CHANGE ORDER NO. 6

Project: Monterey Conference Center Renovation Project, #30C1453
Including Portola Plaza Renovation Project, #30C1601

Proposal Request No. 037
Date Issued: 6/23/2016

Subject: Reinforce Gridline "K" for the "Best Fit Grid" Control Point Shift

WALL ELEVATION ALONG LINE K **01**

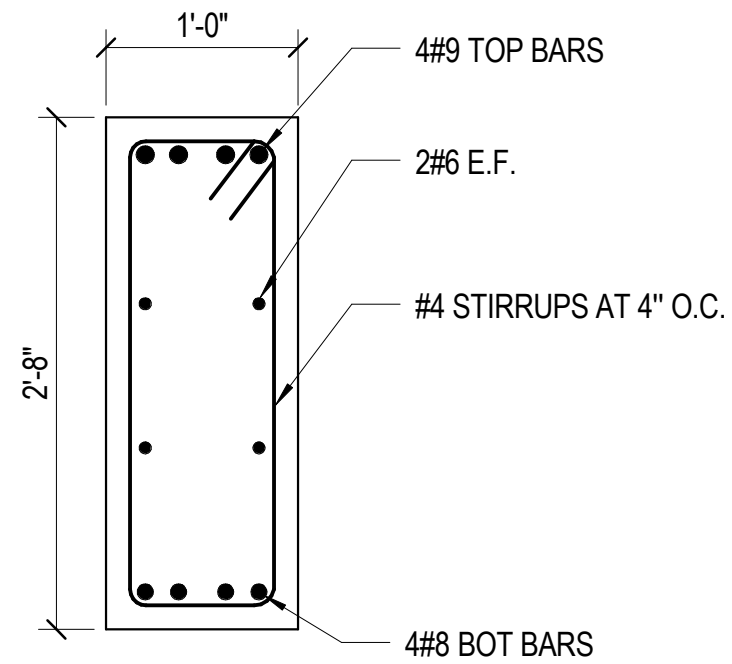
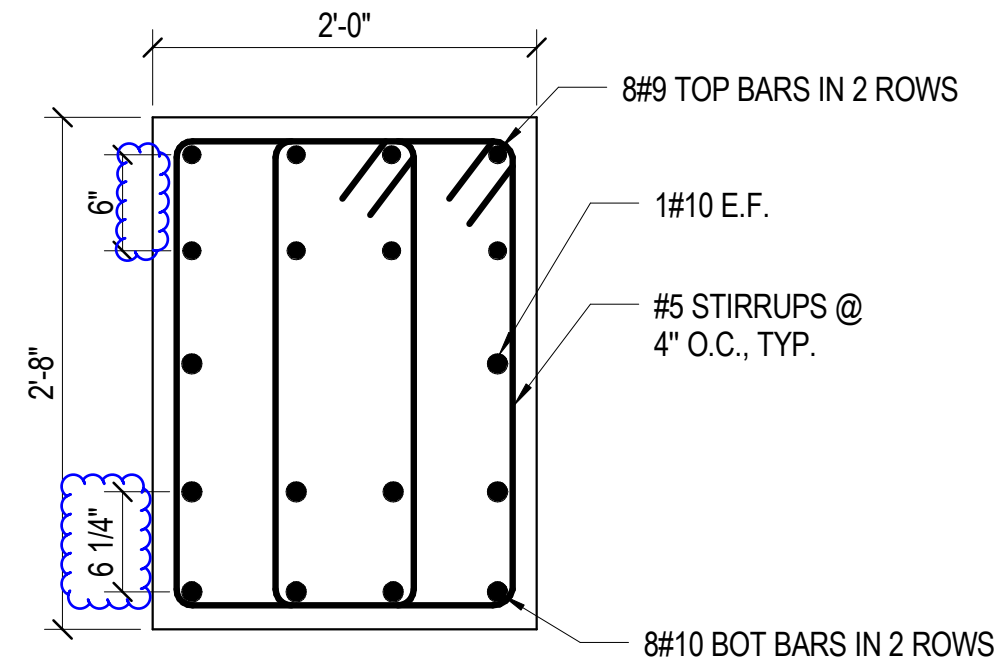
1. The new RC beam at Level 2 along grid line K between approximately grid lines 2.7 to 7.
2. The south end of the existing RC wall to remain along grid line K near grid line 6.8.
3. The existing PT girder at Level 2 along grid line 8 between approximately grid lines J.5 and M.

These reinforcements are illustrated in SSK 030.1, 030.2, 030.3R.1, 030.4R.1, 030.5R.1, 030.6R.1, 030.7R.1 and 030.8 below.

ORIGINAL DESIGN

REVISED DESIGN

SECTION 3

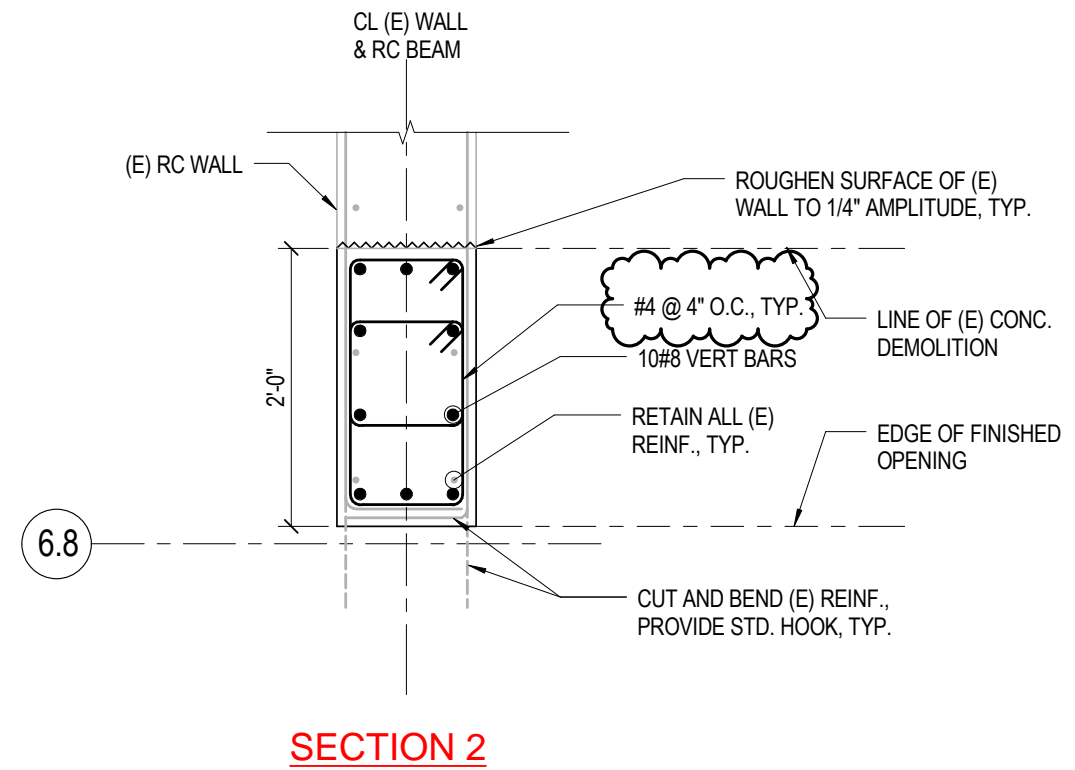
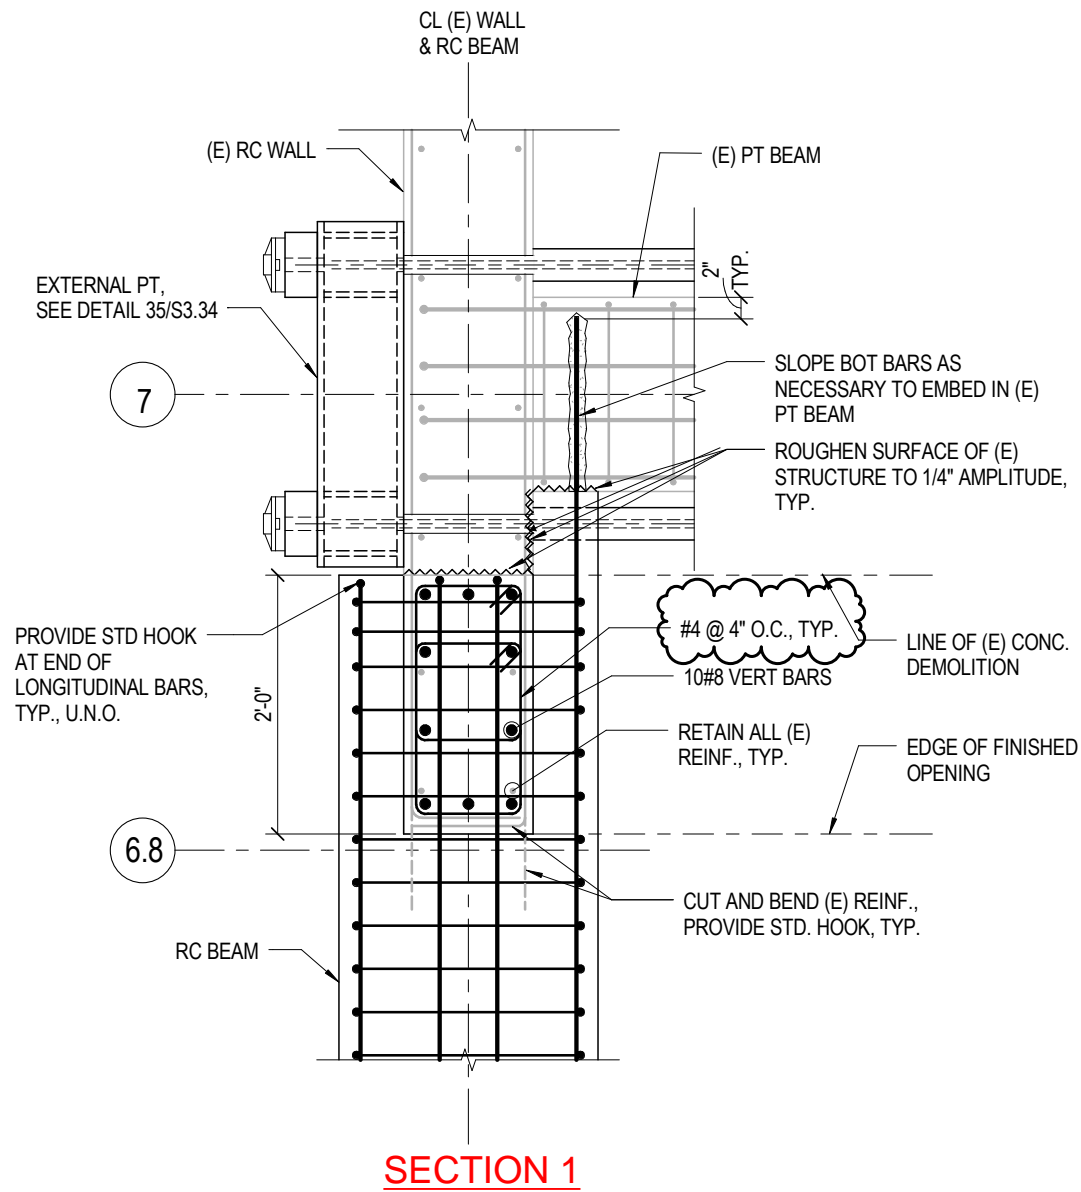
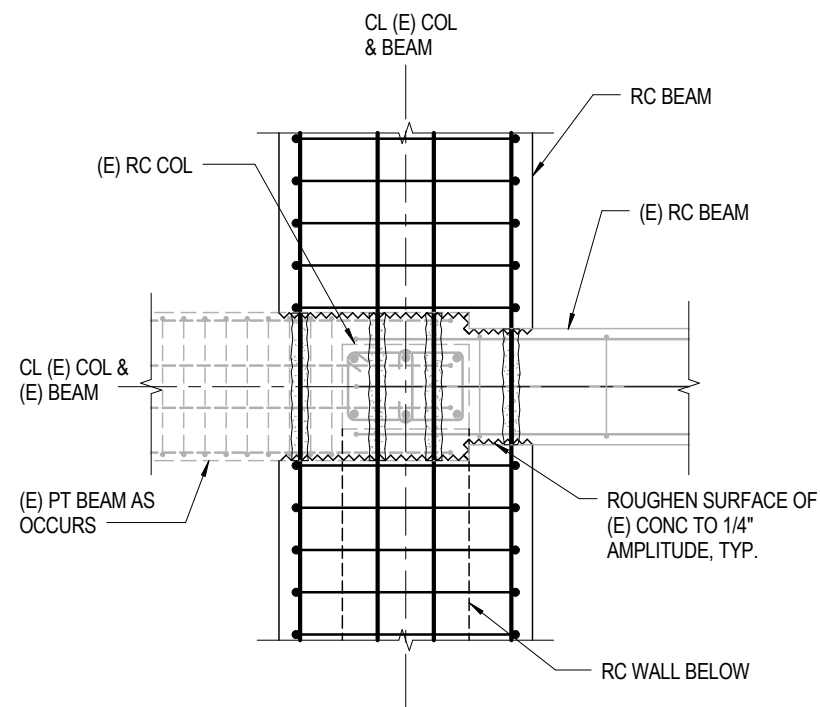
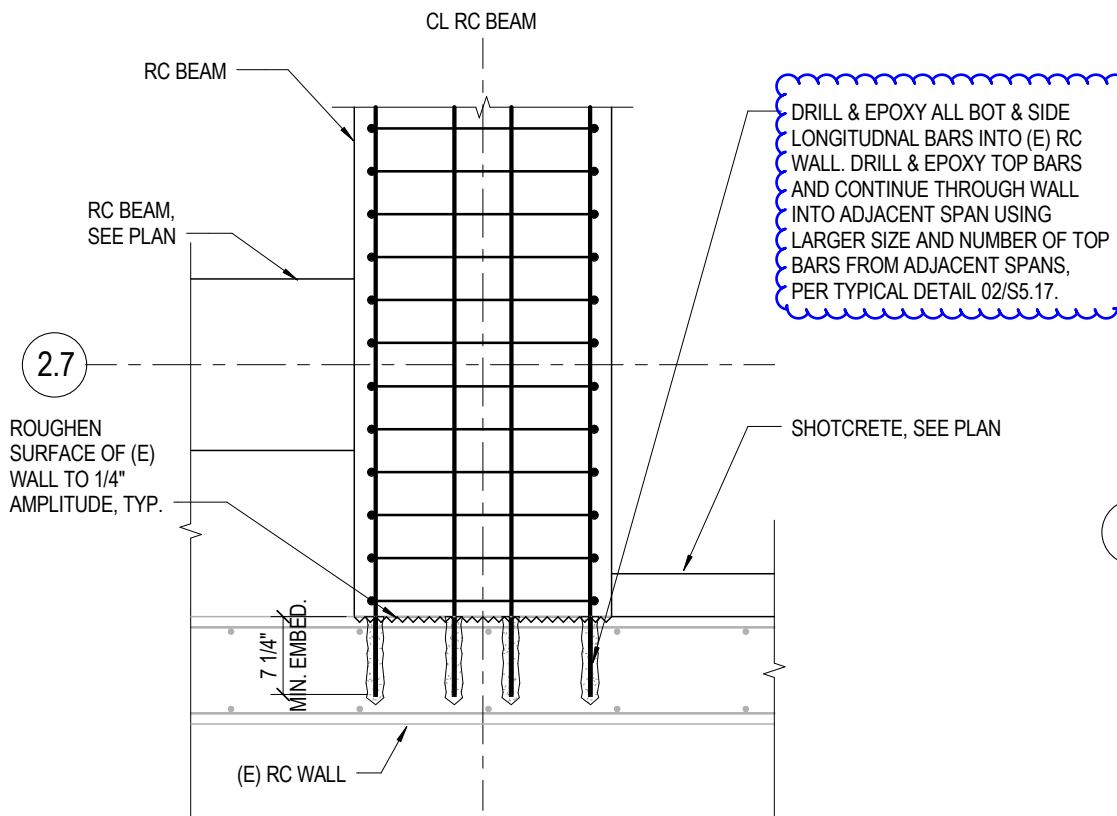
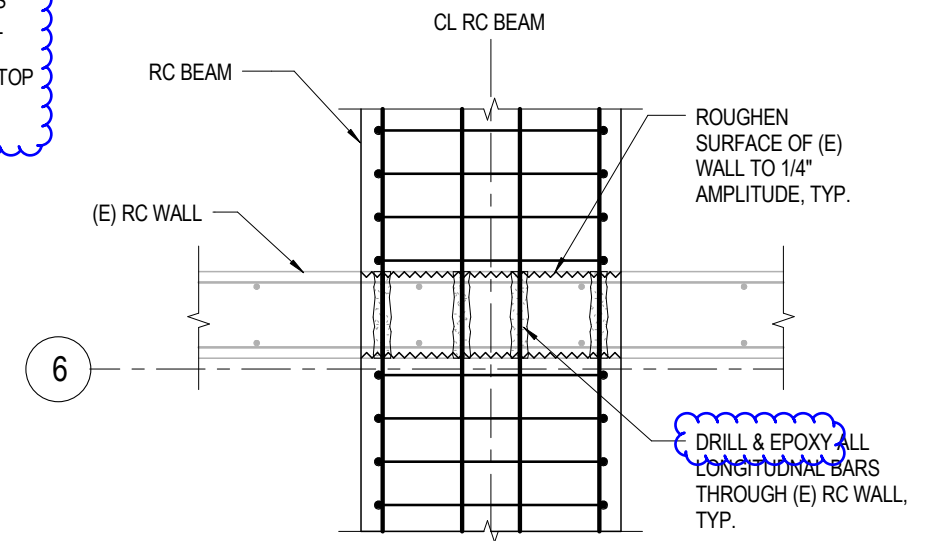
DRILL & EPOXY ALL BOT & SIDE LONGITUDNAL BARS INTO (E) RC WALL. DRILL & EPOXY TOP BARS AND CONTINUE THROUGH WALL INTO ADJACENT SPAN USING LARGER SIZE AND NUMBER OF TOP BARS FROM ADJACENT SPANS, PER TYPICAL DETAIL 02/S5.17.

SECTION B

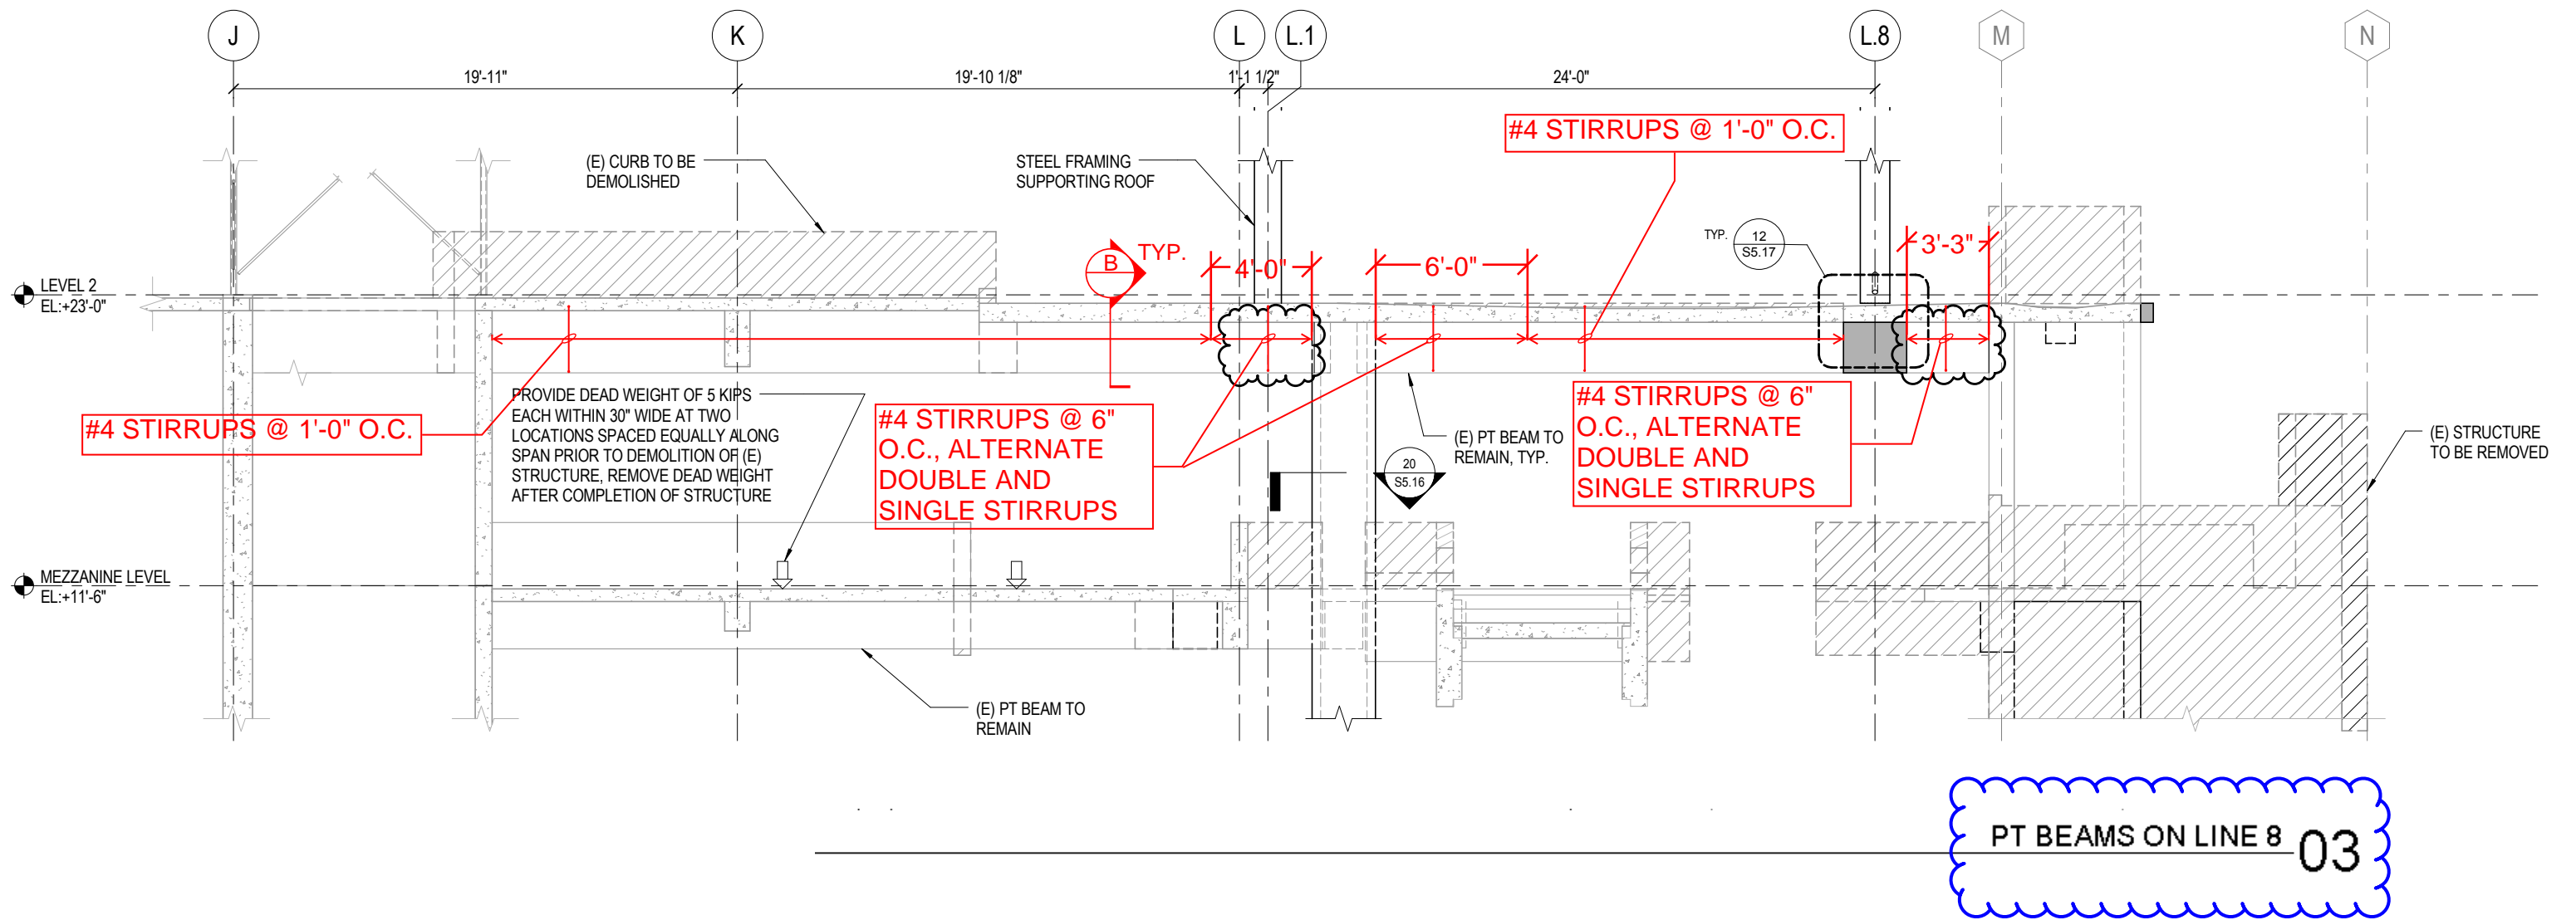
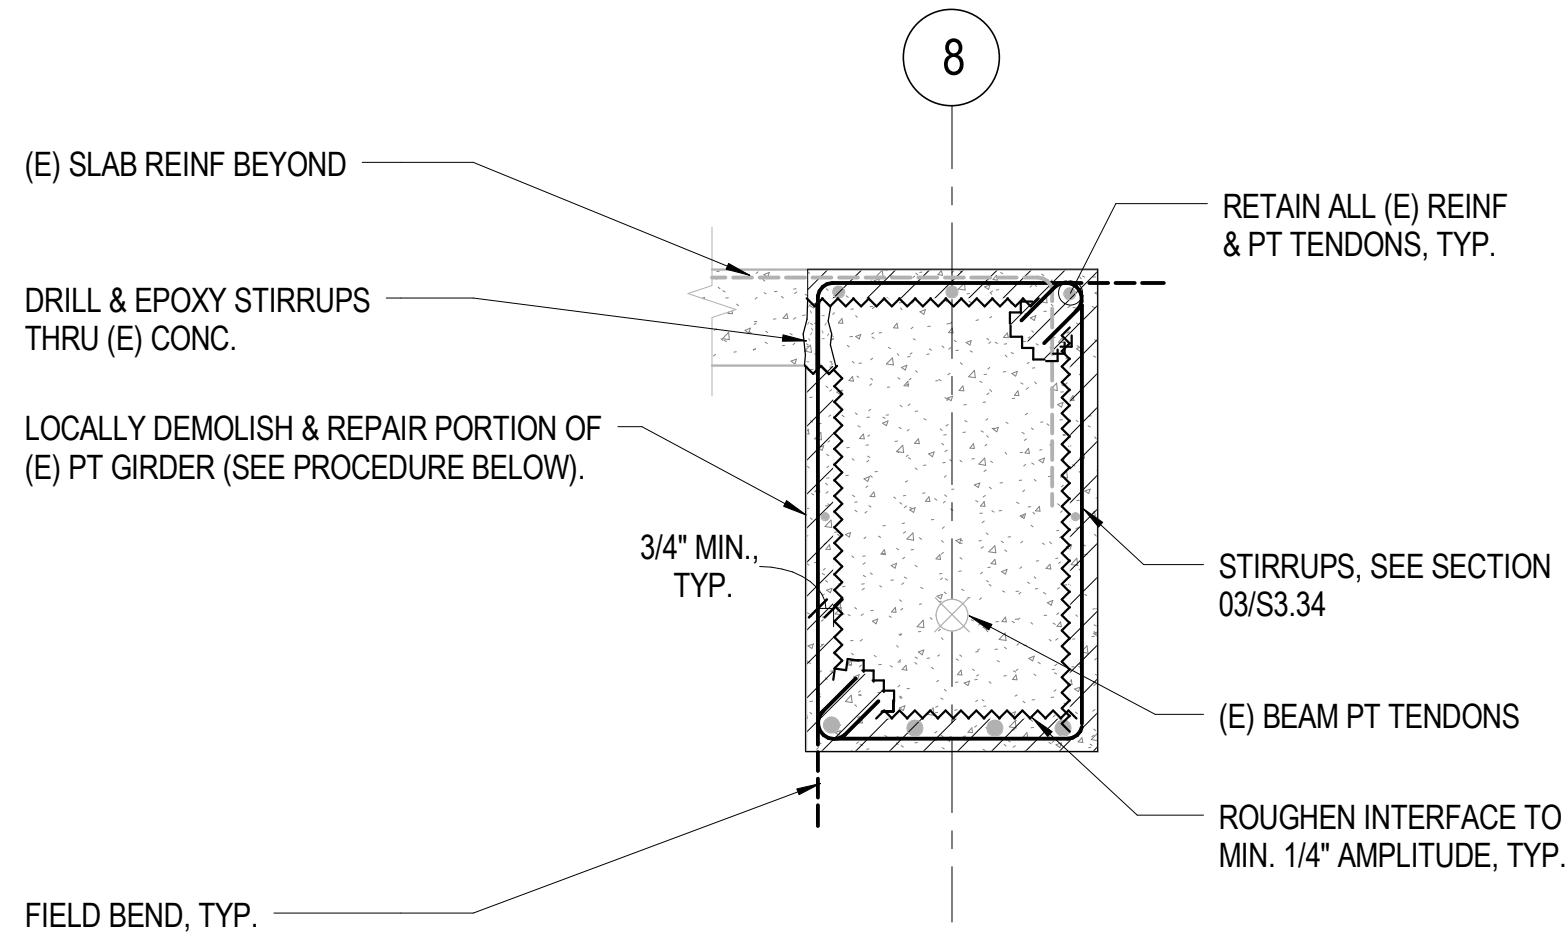
1. LOCALLY DEMOLISH PORTION OF (E) PT GIRDER AT EVERY THIRD STIRRUP LOCATION.
2. INSTALL EVERY THIRD STIRRUP.
3. APPLY SIMPSON FX792LPL BONDING AGENT + SIMPSON FX-261S REPAIR MORTAR TO RESTORE (E) PT GIRDER TO ITS ORIGINAL CONDITION OR BETTER. FOLLOW MANUFACTURER'S SPECIFICATIONS & APPLICATION INSTRUCTIONS REGARDING BONDING AGENT + REPAIR MORTAR. EQUIV PRODUCTS MAY BE USED CONTINGENT ON APPROVAL BY ENGR.
4. WAIT FOR THE COMPRESSIVE STRENGTH OF THE REPAIR MORTAR TO REACH THAT OF THE EXISTING CONCRETE AND THEN REPEAT THE PROCEDURE ABOVE FOR THE SECOND SET OF EVERY THIRD STIRRUP AND THEN FOR THE FINAL SET OF EVERY THIRD STIRRUP.

DRILL & EPOXY ALL LONGITUDNAL BARS THROUGH (E) RC WALL, TYP.
